# Service Bulletin

**Bulletin No. 2010-02**

## Wireless Lower Units with Additional O-Rings

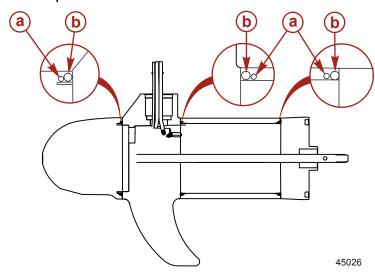
Since May, 2010, three additional O-rings have been installed in the wireless lower units to provide additional sealing capabilities. These additional O-rings are blue in color and are used in conjunction with the red color O-rings.

- **a -** Blue O-ring (0.067–0.073 in. thickness)
- **b** Red O-ring (0.100–0.106 in. thickness)

Refer to the appropriate service manual when servicing the lower unit. The blue and red O-rings must be installed in the specific location from which they were removed.

IMPORTANT: If, upon disassembly of a wireless lower unit, it is determined that there are no blue O-rings used in conjunction with red O-rings, do not install blue O-rings. It has been previously determined that the existing O-rings are providing the sealing protection required.
